### Notice of Specification Change for Certain Sizes of Plastic Screws

Please be informed that changes will be made to the following product: Plastic Screws (PEEK / Hexagon Bolt), model SPE-M4-H, as detailed below.

Before		After

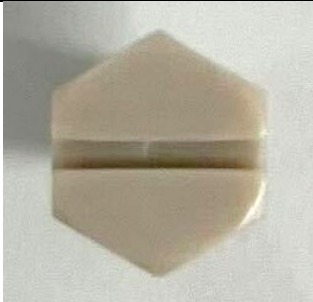
- A slot on the head will be removed.
- There is no change in the main material (PEEK, light brown) or its physical properties.
